DEVELOPMENT REVIEW BOARD REPORT

SUBJECT Carmichael Court

25-PP-2005

Request approval of a Preliminary Plat for a 4-lot single family subdivision on a 4.88 +/- acre parcel.

PRELIMINARY PLAT FOR

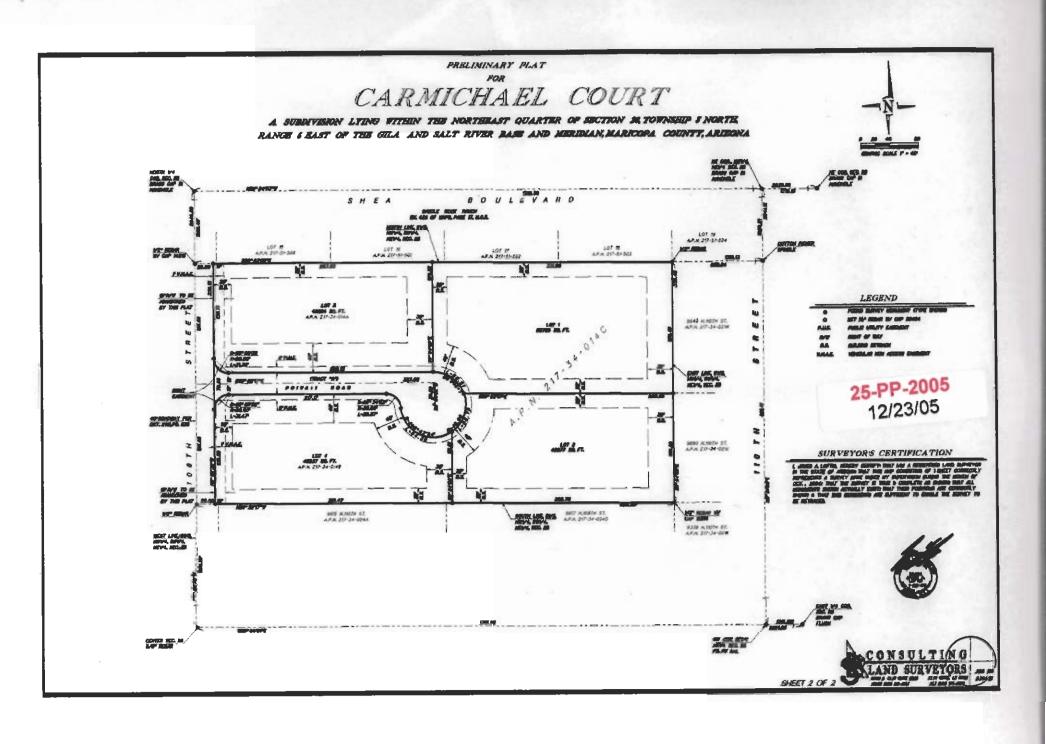
- a. The location and configuration of all site improvements shall be constructed to be consistent with the Preliminary Plat submitted by Consulting Land Surveyors, with a staff date of 12/23/05.
- b. The Design Standards and Policies Manual (DS&PM).

ENTRANCE ELEVATION AGALE: 1" # 20'-0"

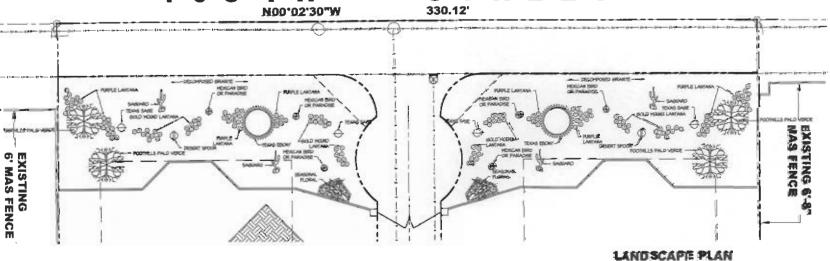
The associated abandonment case allows an additional 10 feet of landscaping along N. 108th St., which has already been landscaped as part of the existing street side yard improvements along N. 108th Street. The existing six-foot wall along N. 108th Street is setback 25-35 feet and finished with tan sand-finished stucco. The applicant proposes to add a new decorative iron gate. The existing landscaping along N. 108th Street consists of desert materials, including Palo Verde and Texas Ebony trees and a variety of desert shrubs. Additional landscaping will be required to satisfy Ordinance requirements that require landscape areas not to exceed more than seven feet between plants.

- 10. All roadway tracts shall be landscaped and maintained by the developer and/or homeowner association.
- 11. With Final Plans submittal, additional plants shall be provided between 108th Street and the project wall to demonstrate landscape areas do not exceed more than seven feet between plants or plant canopies.
